Icon Reserve Pilot Chute Failed to Clear Side Flaps, Ser #IN-I5-12509, DOM Sep 2008

Regarding test-report for pilotchute hesitation on Icon I5 SN#12509

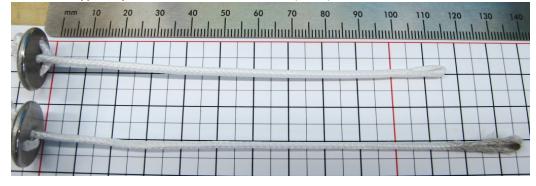
19 November 2012 it was reported that when the pin was pulled for routine repack, the reserve pilot chute failed to clear the side flaps and a video was provided as shown in the captures below.

It was noted from the provided video that the rig was not being worn and the pin was not pulled by its handle. The video shows that it was sitting on the ground and appers to have been pulled by the cable close to the pin, this would mean that this rigger's hand had to have contacted the #5 flap once the pin was clear of the loop interfering with its normal activation.
